There is a plat on the Sub-division agenda (SUB 2000-60; Pizza Hut Pawnee/Hydraulic Addition) which should indicate a need to relocate the existing sewer and dedication of an easement. We have been working with the Architect so hopefully it shows up.

Pawnee at B.N.S.F. Proposed R.O.W. Acquisition

\*Pizza Hut Pawnee/Hydrolic Addition - FINAL PLAT

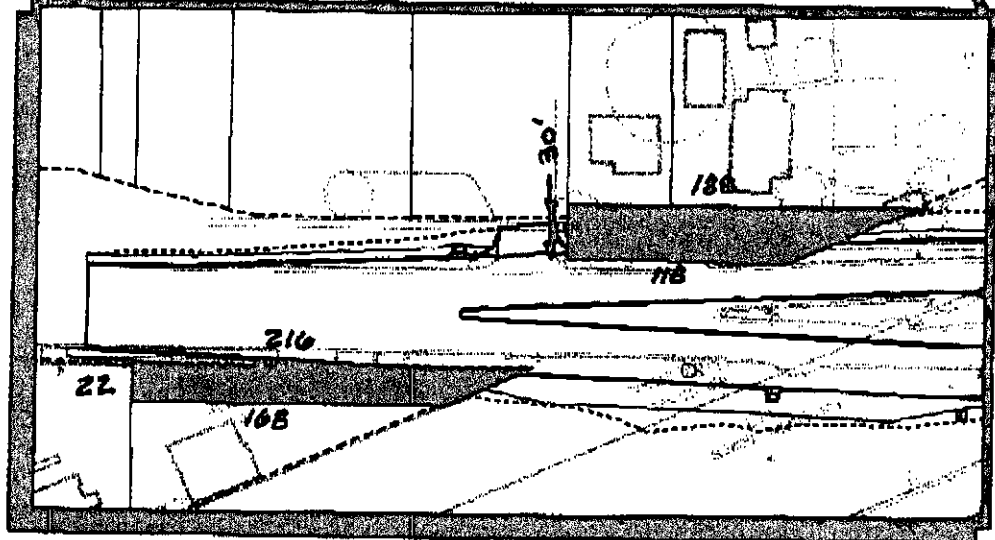
*N-S dimensions  
are fixed to existing  
Rail E/W and lot  
lines. All dimensions  
here are approximate*
